SFF-TA-1002

Protocol Agnostic Multi-Lane High Speed Connector

Rev 1.5.2~~1~~

~~April 4, 2025~~ April 29, 2024

FIGURE 5-35. AIC MATING CARD PROFILE DIMENSIONS

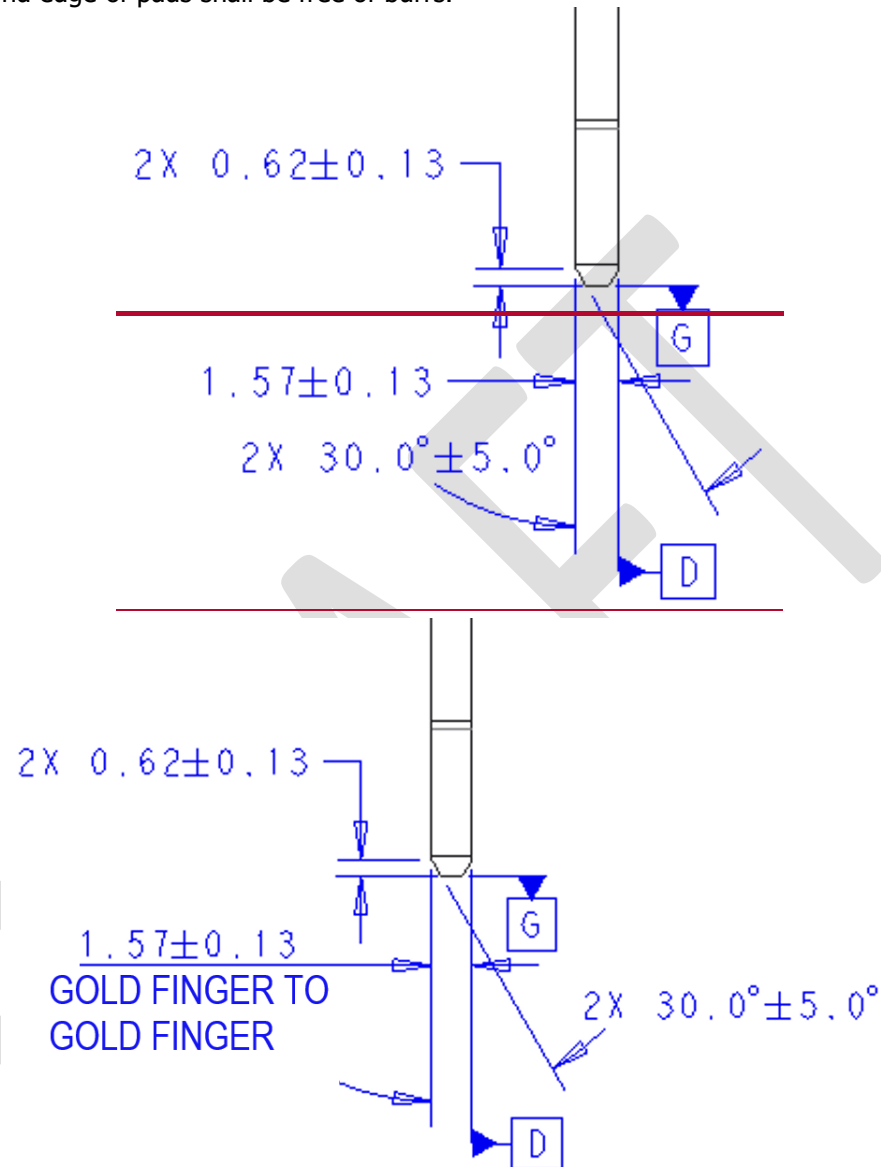
- Changed Figure 5-35 to clarify card edge thickness requirement.
- Editorials per comment resolution.
